**Lannan Road Development (the site)
for Zoning Amendment Bylaw No. 2973**

Preliminary Infrastructure Master Plan (PIMP)

May 22, 2025

**Re: Lannan Road Development (the site) for Zoning Amendment Bylaw No. 2973
 Preliminary Infrastructure Master Plan (PIMP), Rev 2, Updated May 22, 2025**

Figure 3 – Typical Road Section – Lannan Road and Road A

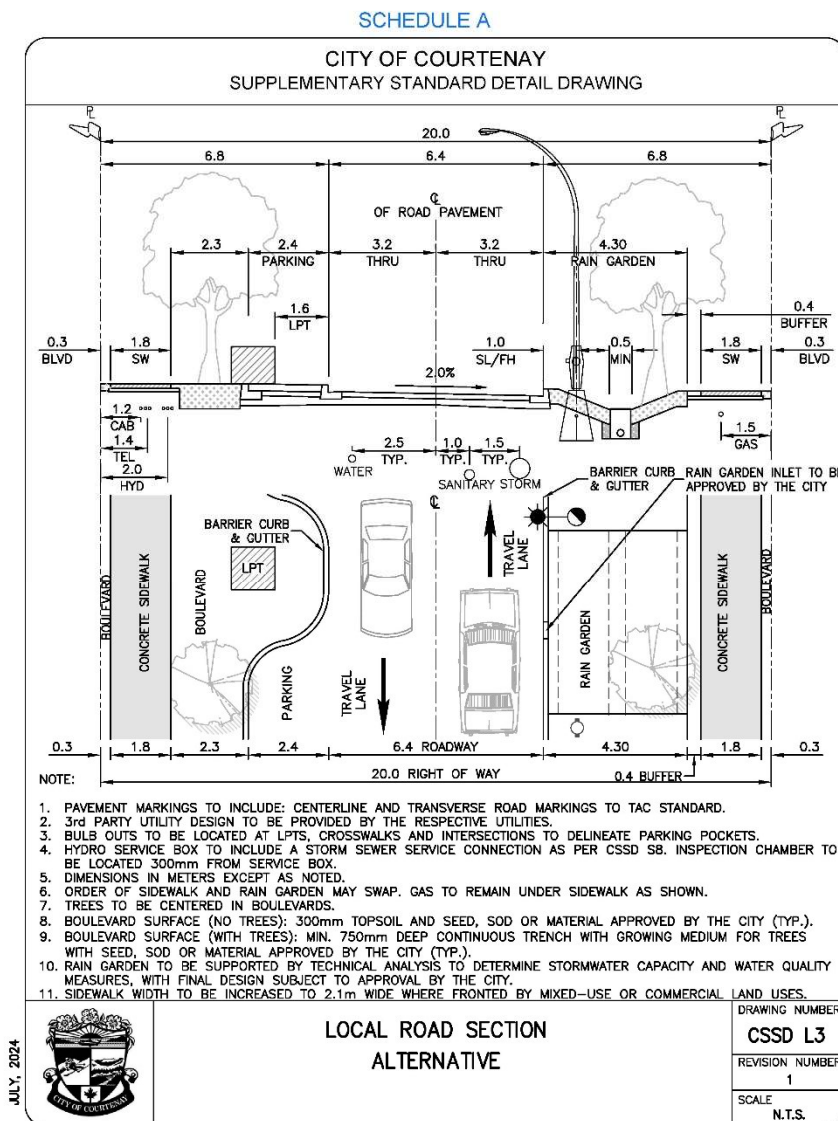
- c. Cross sections:
 - i. Figure 3 in Koers Infrastructure matches with Figure 2 in Westplan Transportation Hierarchy – shows bioswale facilities
 - 1. City request 1.8-2.0m sidewalks (not 1.5m).

This new typical section has recently been adopted into Bylaw 2919. It provides a bio-swale on the low side (labelled as a “Rain Garden”), which will provide the infiltration facility required to meet the goals of the stormwater management system. This is discussed in detail in the accompanying PSMMP. It is important to note that the bio-swales do not run along the entire length of the roadways. These bio-swales will be located near the catch basins and strategically placed between driveways to avoid other utilities where possible. Please refer to the PSMMP for further details.

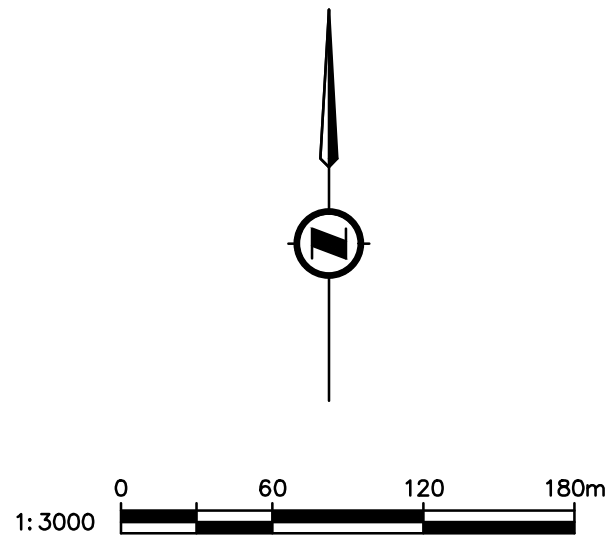
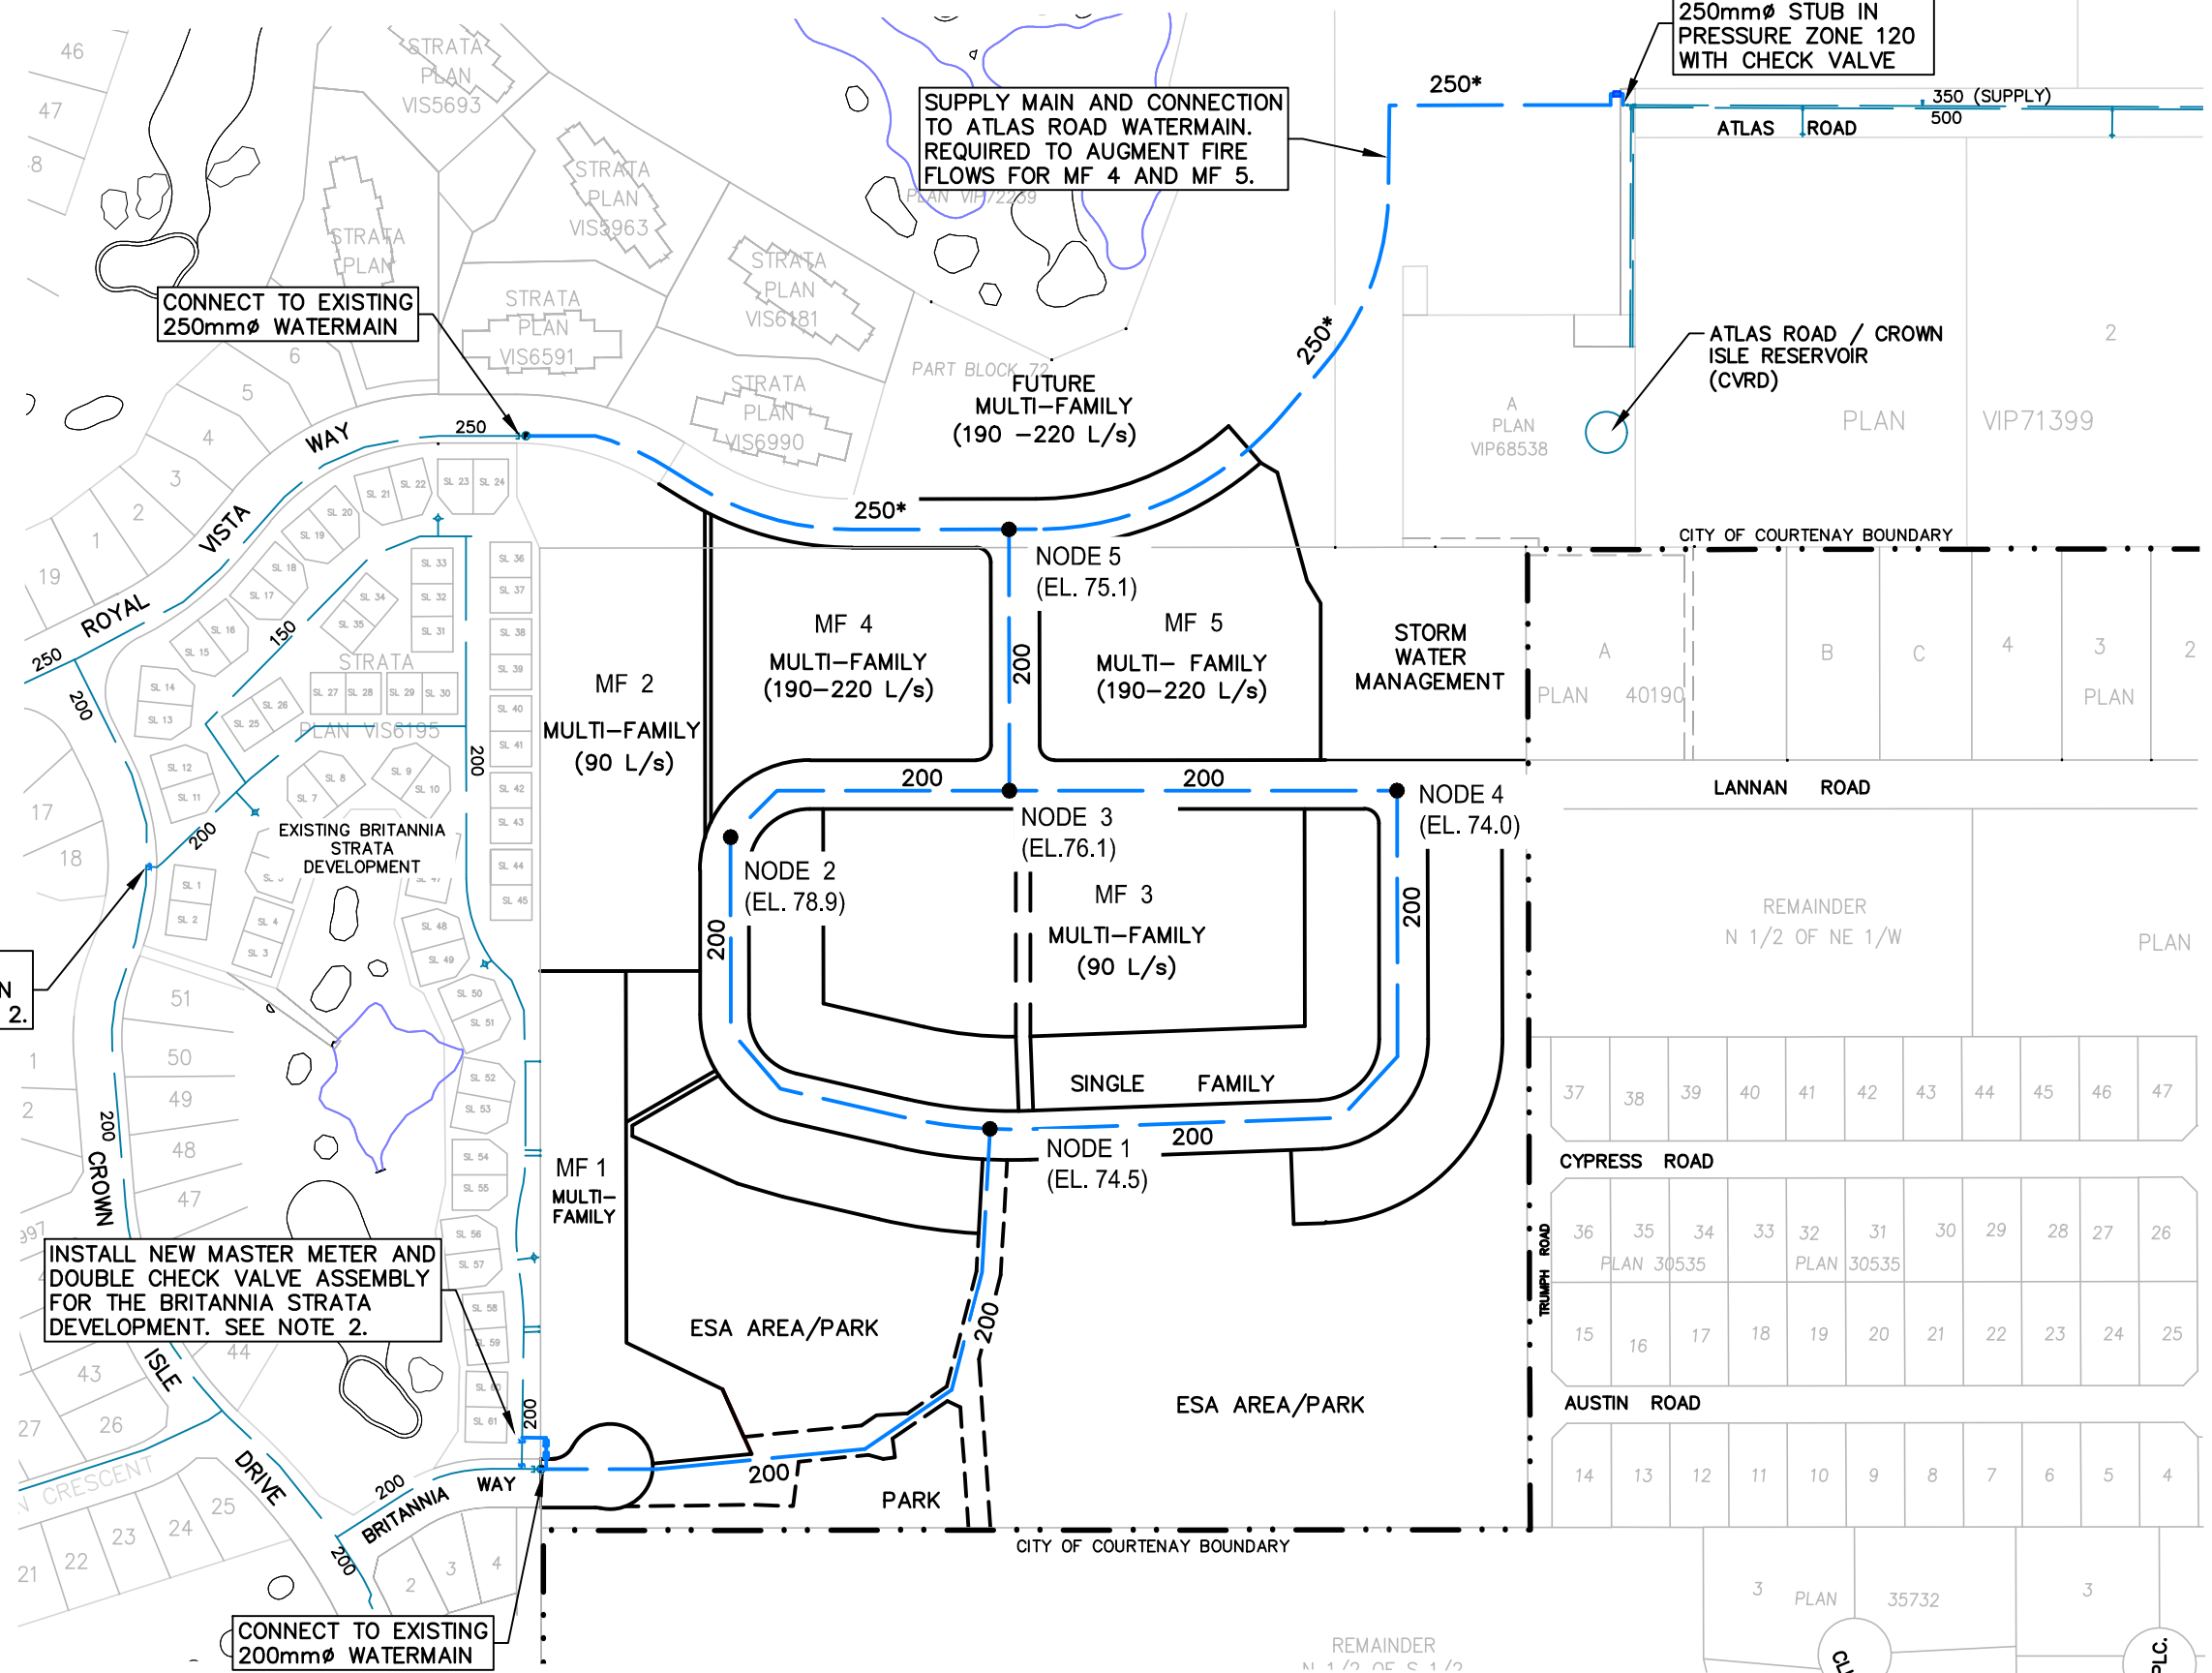
- XXII. Figure 4 does not show cycle facilities in the Royal Vista cross section such as section CSSD CRB as previously noted.
- XXIII. Section 4.1 - the Koers Figure WS – does not identify the number of MF dwelling Units in phase 4 and 5 that have not been designed, highest and best use should be assumed for fire flow calculations and Geo-Advice should re-run the model for the noted possible 220 L/s at the expense of the applicant.

Figure WS shows the conceptual meter and double check valve assembly location on Britannia Way, which is to be confirmed during the detailed design process.

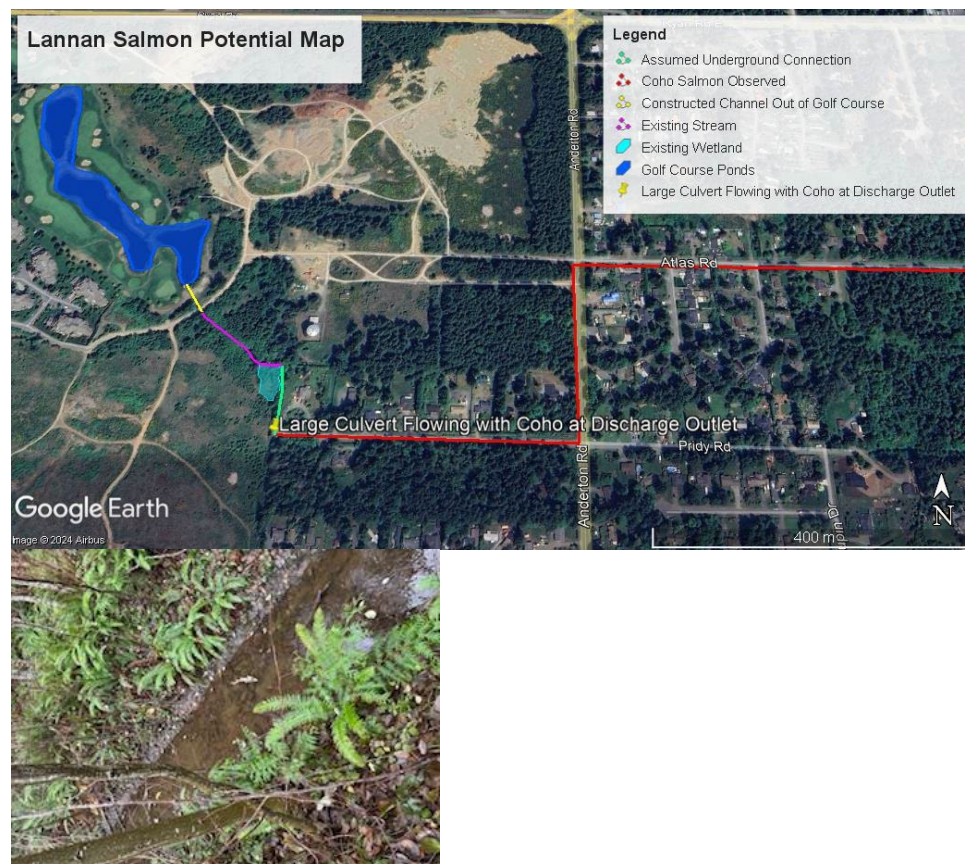
The proposed stormwater settling pond(s) along the northeastern corner of the property noted above does not currently consider recent fisheries observations made by Cascadia Biological Services (Thomas Roy) in December 2024 and passed along to applicant on February 11, 2025. During that time, spawning Coho salmon were observed in the shallow ditch running along Lannan Road see photo below.

The fish at the end of Lannan were documented travelling through an 800mm CSP culvert into the wetland complex along the northeastern corner of the property as well as into the rock riprap immediately south of the ponds on the golf course see above overview map and below potential Salmon map for Lannan. The presence of fish at this location defaults the proposed stormwater pond wetland area and adjacent creek as waterbodies under the Riparian Areas Protection Regulations (RAPR) legislation. Flows from this area eventually make their way into the Little River. The Master Plan needs to address this condition and utilize the RAPR to inform infrastructure design in the MP for both PIMP and PSMMP. There may also be impacts on the PPMP on park areas.
